DEVELOPMENT REVIEW BOARD REPORT

CASE NUMBER/ PROJECT NAME	42-DR-2005 Monte Cristo Office/Warehouse		
LOCATION	7469 E Monte Cristo Avenue, which is west of the southwest corner of 76 th Street and Monte Cristo Avenue		
REQUEST	Request approval of a site plan and elevations for a two-story office/industrial building.		
OWNER	7469 Monte Cristo LLC 480-585-3325	ENGINEER	Landmark Engineering
ARCHITECT/ DESIGNER	Irwin G. Paternack AIA & Associates, Inc. 602-279-2808	APPLICANT/ COORDINATOR	Dick Presto Irwin G. Paternack AIA & Associates, Inc. 602-279-2808
BACKGROUND	<p>Zoning.</p> <p>The site is zoned Industrial Park (I-1) District. This district allows for manufacturing, office and warehouse uses as permitted uses.</p> <p>Context.</p> <p>The site is located within the Scottsdale Industrial Airpark Unit #6 plat. Adjacent Uses:</p> <ul style="list-style-type: none">• North: Monte Cristo Avenue and manufacturing, office and warehouse uses with I-1 zoning.• South: Manufacturing, office and warehouse uses with frontage along Terra Buena Lane with I-1 zoning.• East: Manufacturing, office/ warehouse uses with I-1 zoning.• West: Manufacturing office/warehouse uses within the Scottsdale Airpark

LANDSCAPE PLAN

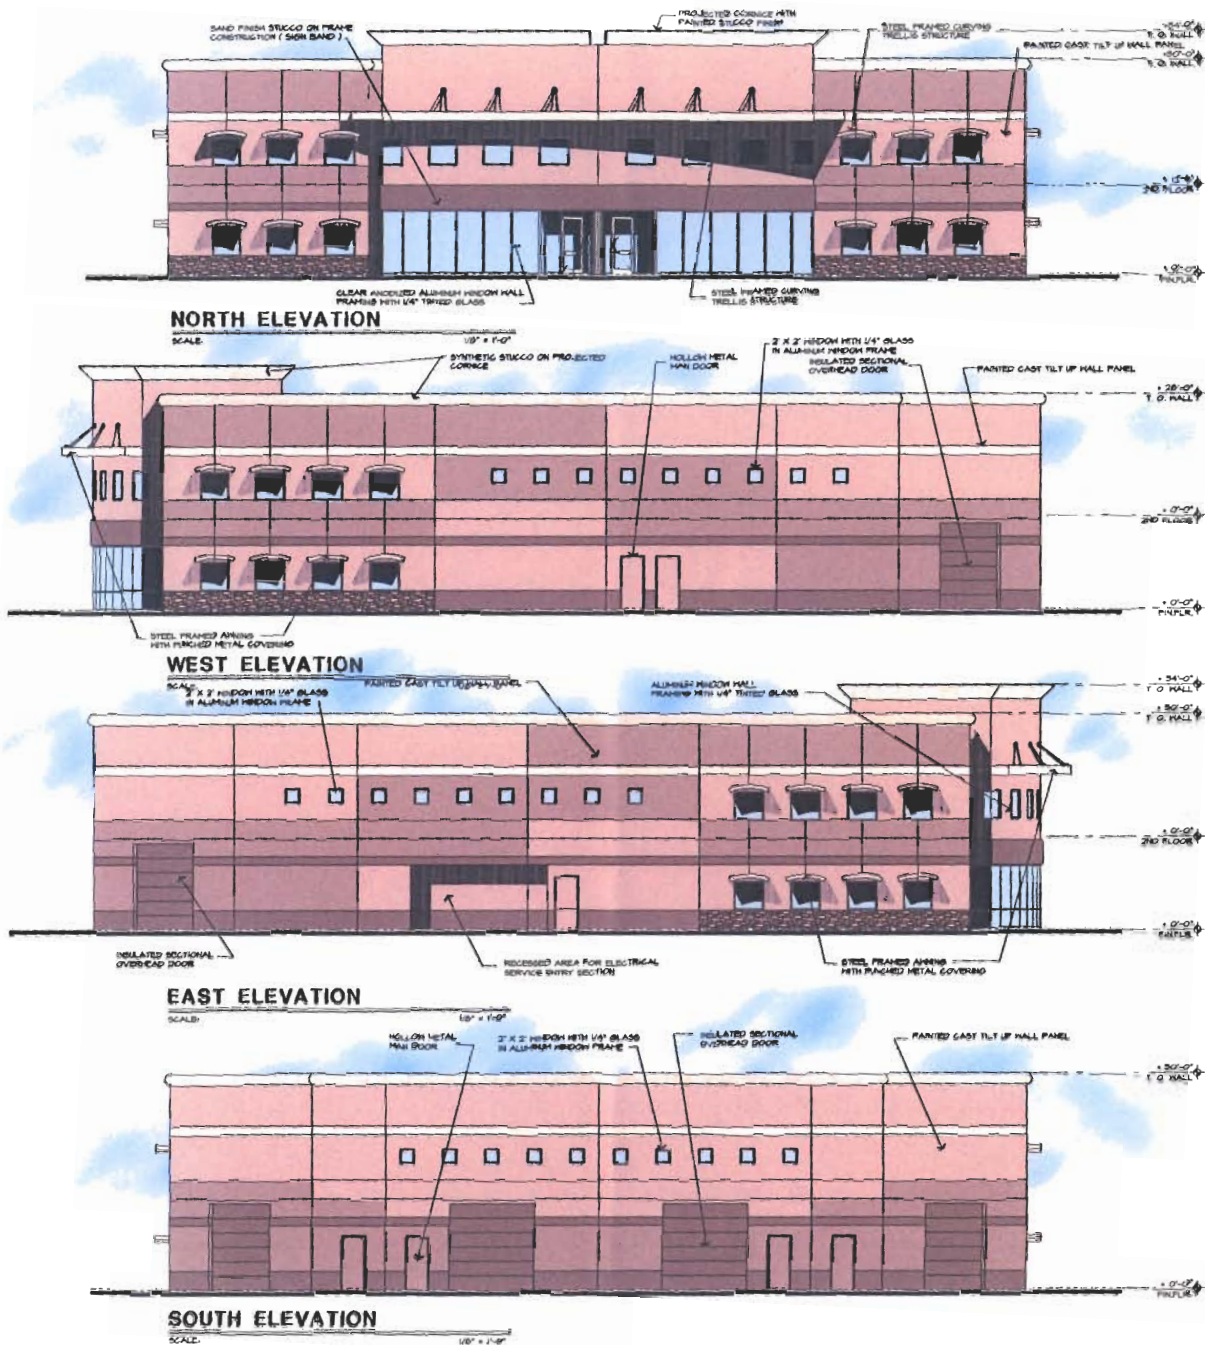
- c. Landscaping, including quantity, size, and location of materials shall be installed to be consistent with the Landscape Plan sheet L-1 submitted by Irwin G. Pasternack AIA, P.C. with a staff receipt date of 5/13/2005.

- D. Fifty percent of trees shall be mature as defined in the Zoning Ordinance.
- E. Shrubs and ground covers immediately adjacent to and within the Right-of-Way shall have a minimum five-gallon container size.
- F. Planting density in areas of mass plantings of shrubs and ground covers in the Right-of-Way shall be at 4 feet on center spacing or closer.
- G. Planting density in areas of mass plantings of shrubs and ground covers on site shall be 7 feet between projected mature canopies or closer.
- H. All trees within the public utility easement shall be relocated to an area just outside the easement.

ELEVATIONS
24x36
4-12-05
S

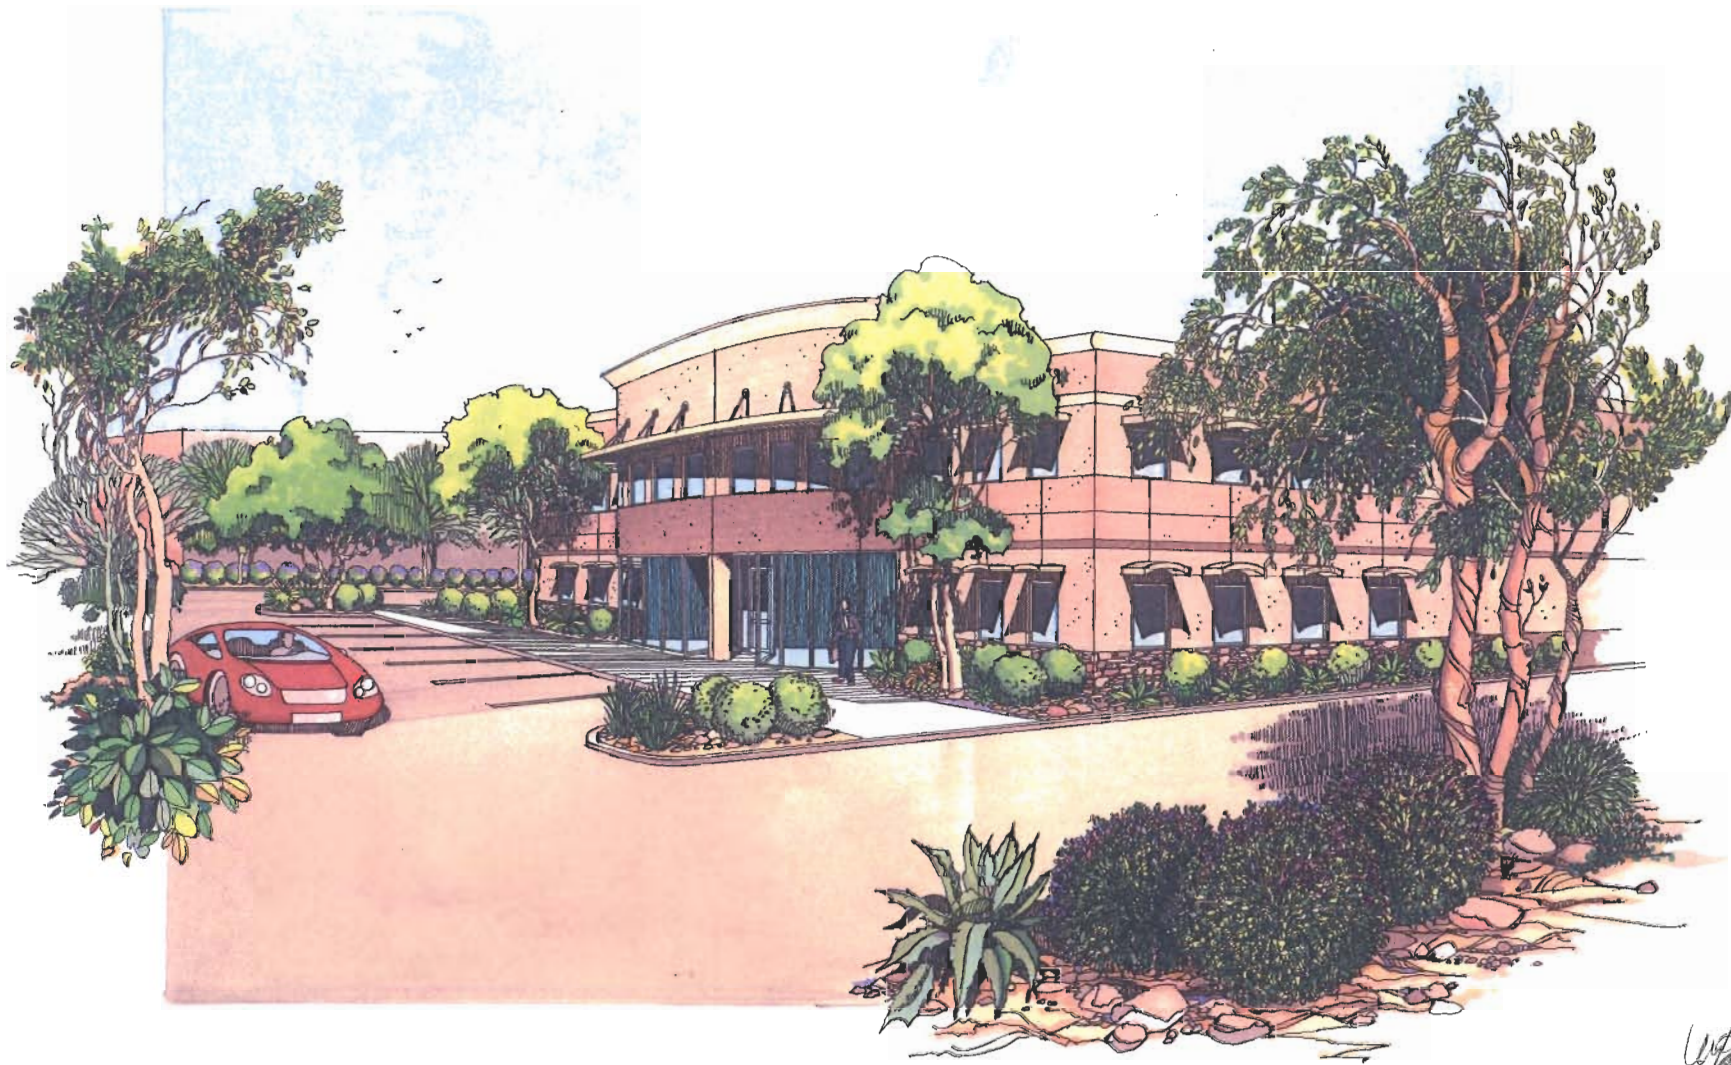
- a. Architectural elements, including dimensions, materials, form, color, and texture, shall be constructed to be consistent with the building elevations submitted by Irwin G. Pasternack AIA, P.C. with a staff receipt date of 6/20/2005.

2. The face of the service entrance section(s) shall be flush with the building façade and painted to match the building.
3. All exterior mechanical, utility, and communications equipment shall be screened on all sides by parapet or wall that matches the architectural color and finish of the building. Wall or parapet height for roof-mounted units shall meet or exceed the height of the tallest unit. Wall height for ground-mounted units shall be a minimum of 1 foot higher than the tallest unit.

9. Transformer screen walls shall meet the standard clearance specifications of the utility provider.
10. Overhead sectional doors shall be recessed into the wall no less than four inches from the exterior face of the building, excluding external detailing.
